Re: Public Hearing - Upper Merideth Branch (University Park) Streambank Stabilization Sewer Project

WILDHORSE RIVERWORKS, INC. (WRI)

REPORT FOR CITY OF COLUMBIA STREAM PROJECTS.

Figure 2: Manhole w/ intersecting lines

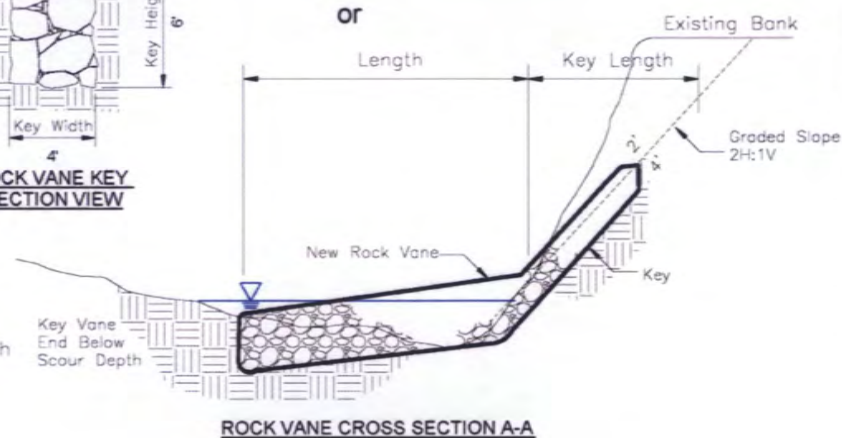
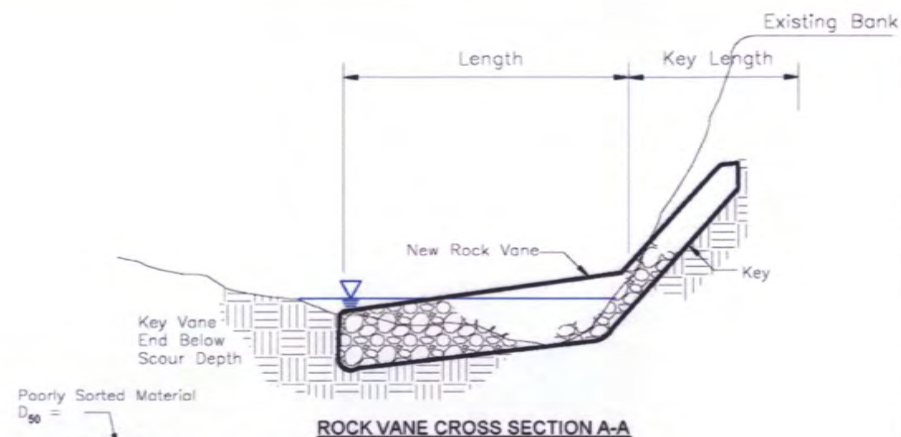
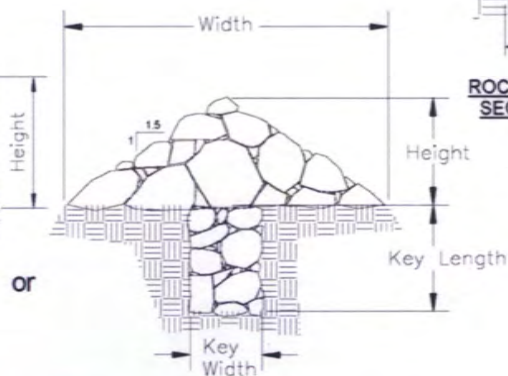
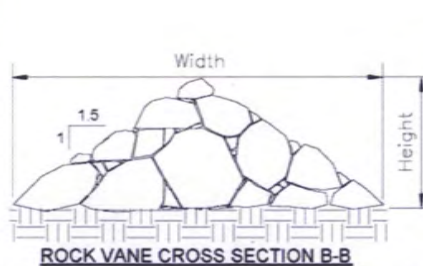
WRI personnel visited this site, with City of Columbia Engineering Staff on October 16, 2014. We walked the stream channel from Grant Lane through Chapel Hill Road to near the end of Kohler Circle. Numerous areas of eroding banks and exposed sewer lines exist throughout the reach. Most eroding banks can be remediated with the use of rock toes (basically $\frac{1}{2}$ LPSTP in cross section). Exposed sewer lines that cross perpendicular with the stream channel can be remediated by constructing engineered rock riffles over the lines. A typical design detail for engineered rock riffles is attached as Appendix E. Sewer lines, running parallel with the channel can be protected using the rock toe. The exception to this is in the area of the exposed manhole with 3 intersecting sewer lines, shown in figure 2. The manhole and lines or stream channel will need to be relocated. Channel relocation will require the removal of several large oaks and/or sycamore trees. Relocation of the manhole and lines may be less expensive and will cause less damage to the existing riparian vegetation.

If channel relocation is chosen as the remediation method, the new channel should be the same length as the existing channel. This will help prevent further stream channel incision and will make 404 permitting easier.

Channel Bend south of Chapel Hill Road

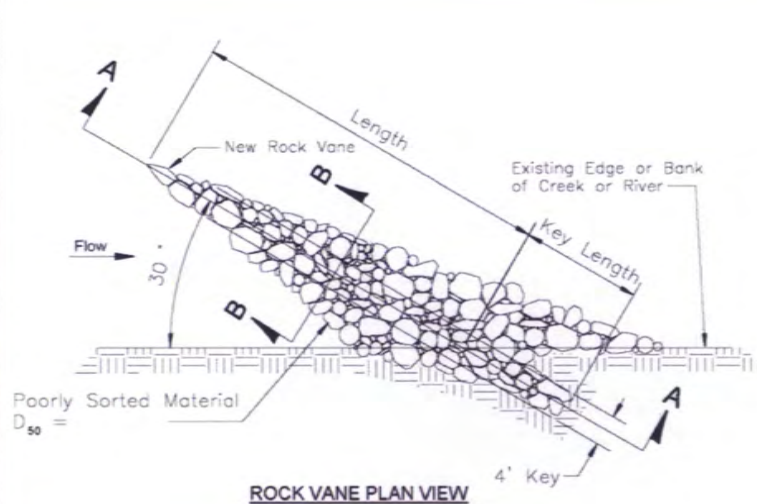
The bend south of Chapel Hill Road has several issues including woody debris blocking the channel, erosion on both banks, and a gully forming on the left bank due to overbank flow. The limbs and other woody debris should be removed. A rock toe should be installed along the right descending bank and tied into an engineered rock riffle. The inside bend of the meander may need to be reshaped and a gravel bar constructed in its place. On the left descending bank, a rock toe should be constructed, starting at the engineered riffle and a rock chute should replace the gully. The rock chute should be “keyed” into the surface on the top end and the bottom connected to the rock toe. A typical rock chute detail is attached as Appendix F.
